## Planning Commission Staff Report

**Project Type:** Site Development Section Plan

**Meeting Date:** May 11<sup>th</sup>, 2015

**Description:** **Chesterfield Blue Valley, Lot 1H (Gander Mountain)**: A Site Development Section Plan, Landscape Plan, Lighting Plan, Architectural Elevations and an Architect's Statement of Design for a 6.015 acre tract of land zoned "PC" Planned Commercial District located west of Outlet Boulevard, north of its intersection with Olive Street Road.

**Figure 3 – Colored Site Plan for Gander Mountain**

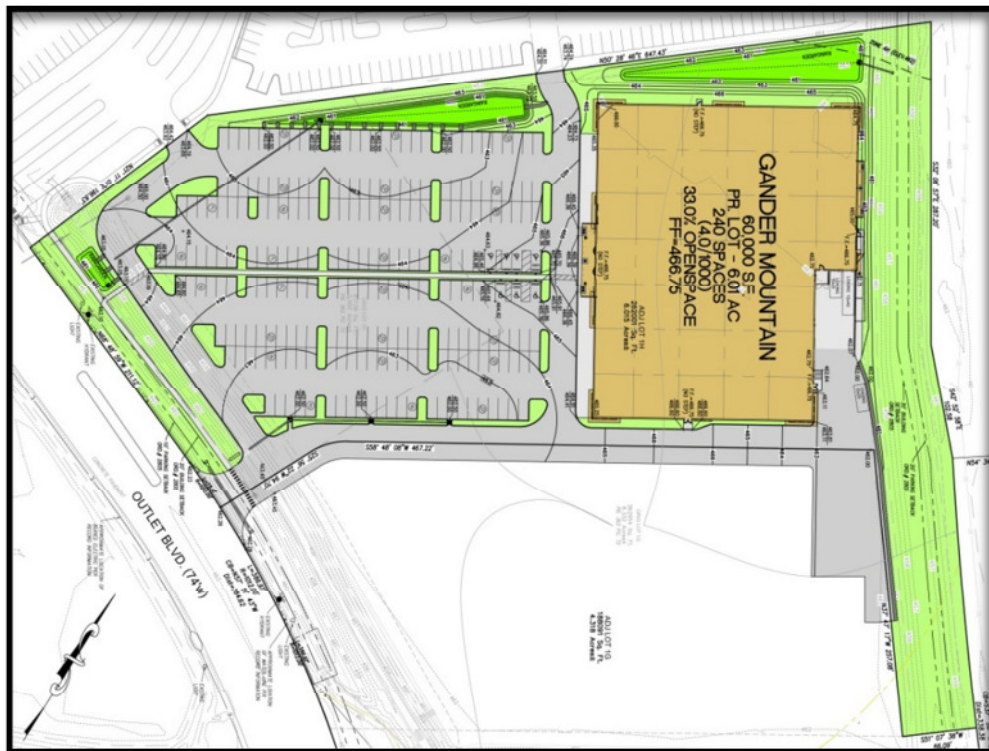
1. *Add landscaping along the front elevation, between the brick columns and building entrance. These can be planting beds or planters.*

In response to this recommendation, the applicant has provided 4, 18 feet long, planter boxes in front of the building which will include shrubs ranging from 3 to 6 feet in height. This change has been reflected on the Site Development Section Plan and Landscape Plan.

1 FRONT ELEVATION  
3/32"=1'-0"

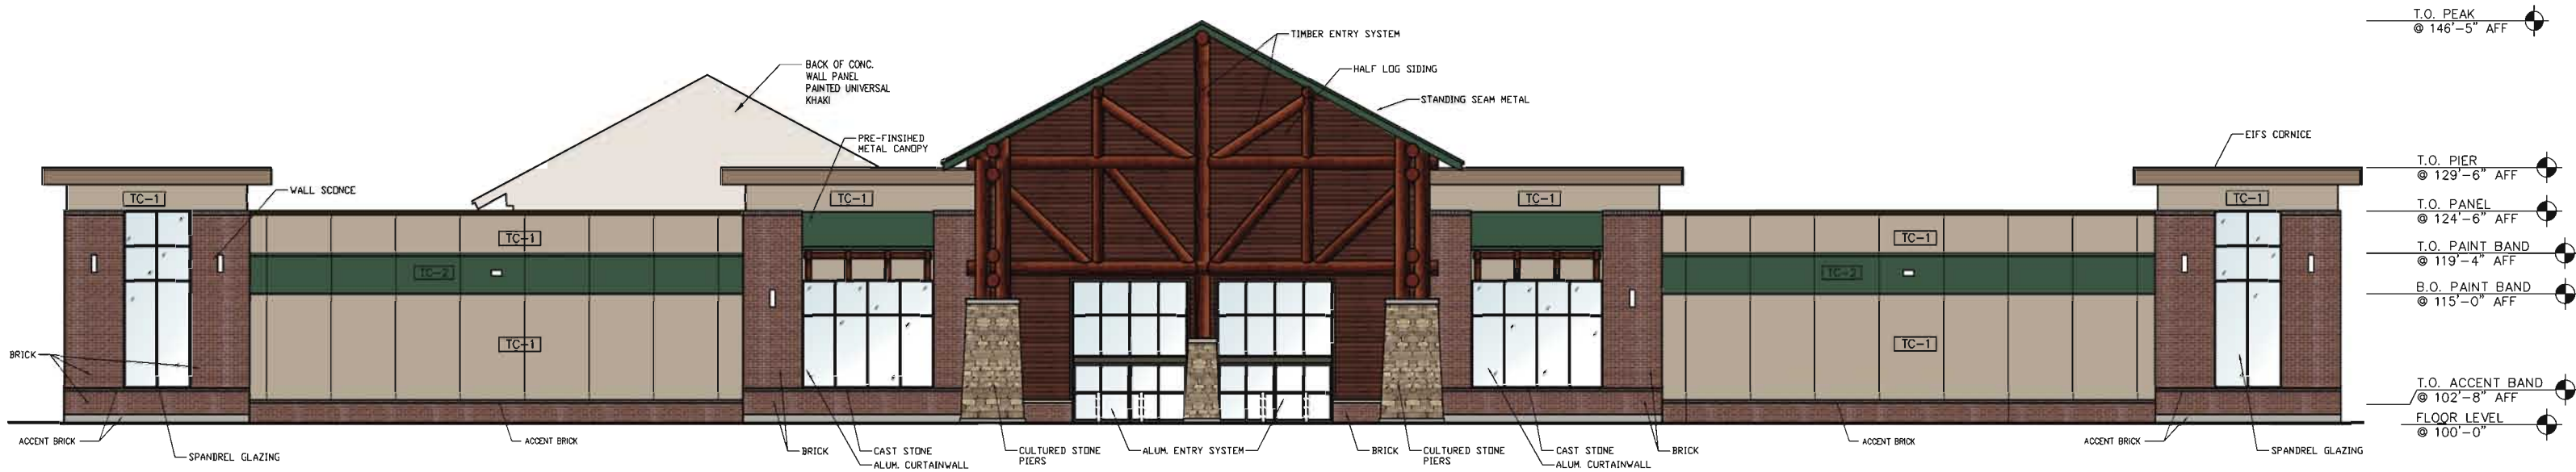
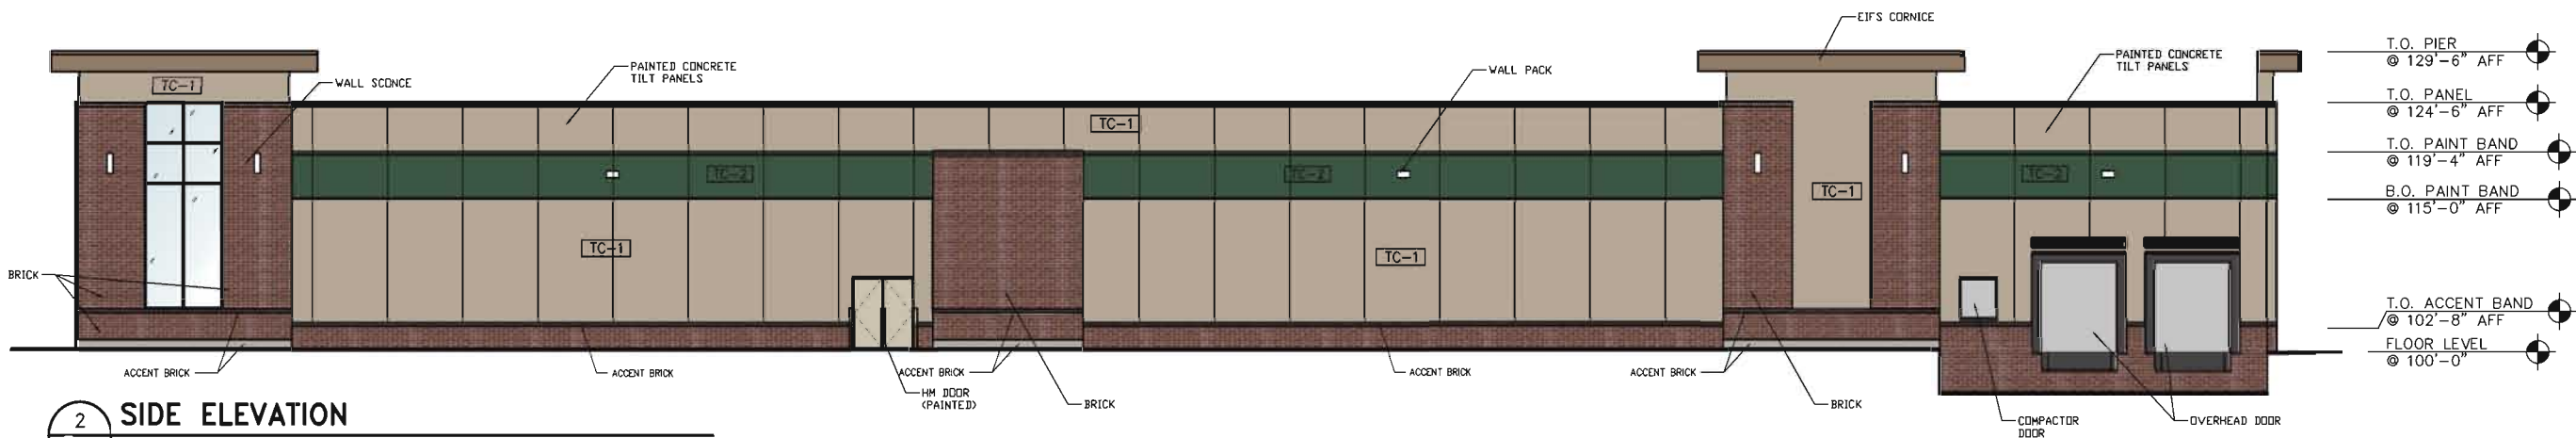
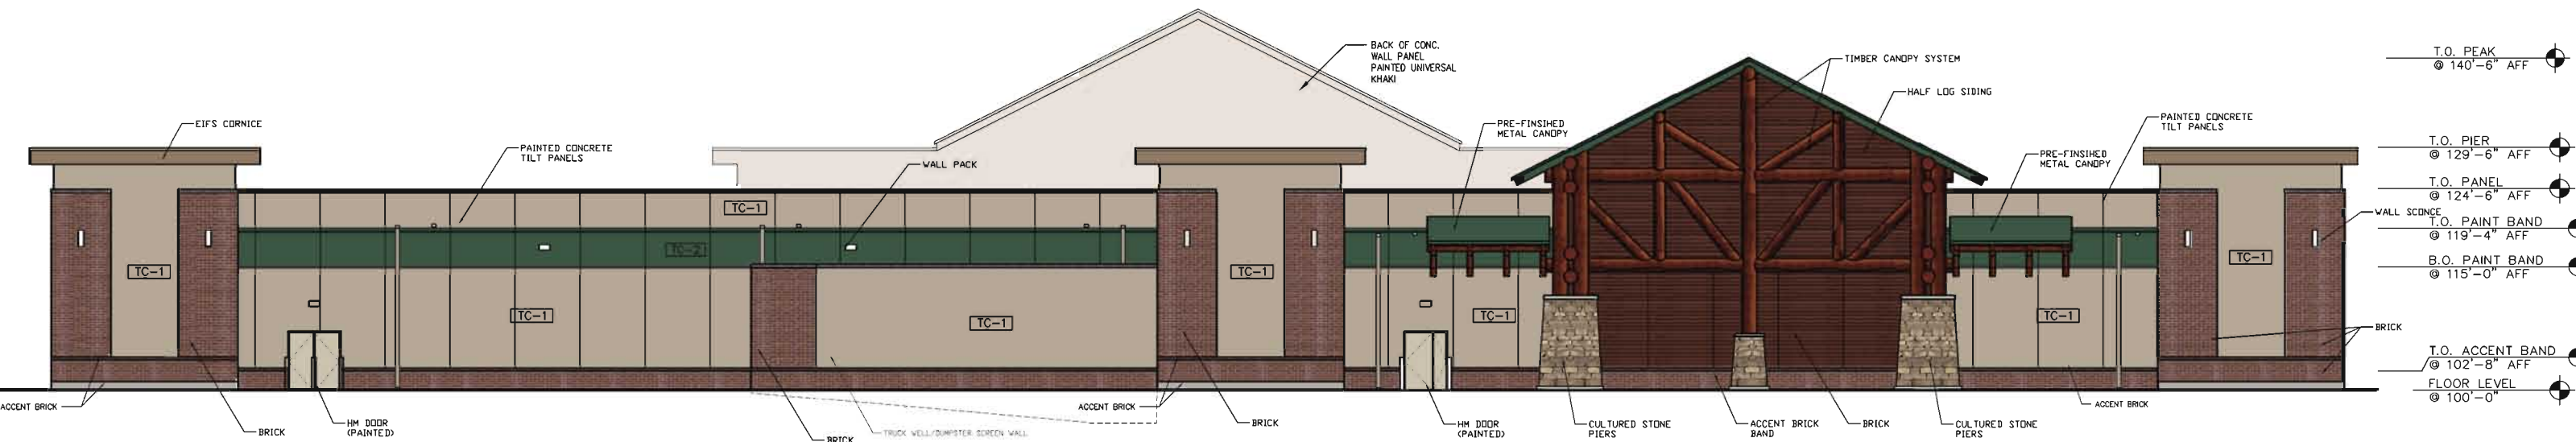
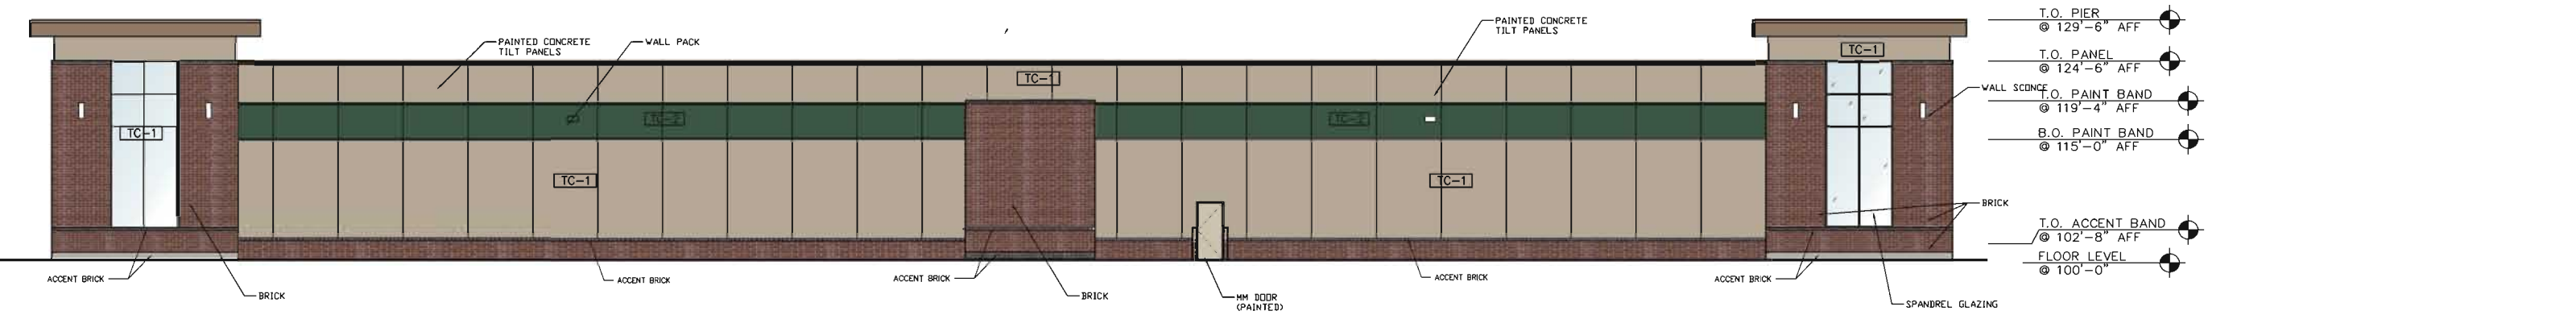
2. *Clearly show all the reveals on the building.*

3. *Ensure the rooftop equipment is completely screened by the parapet wall and provide Staff with sight-line studies from all property lines.*

The applicant has provided updated elevations showing the reveals in the building. There is a 1.5 inch chamfered reveal above and below the green band on the building, with additional reveals where the concrete panels meet.

A sight-line study was submitted and has been included in the Planning Commission's packet. All the roof-top equipment will be screened by the proposed parapet walls.
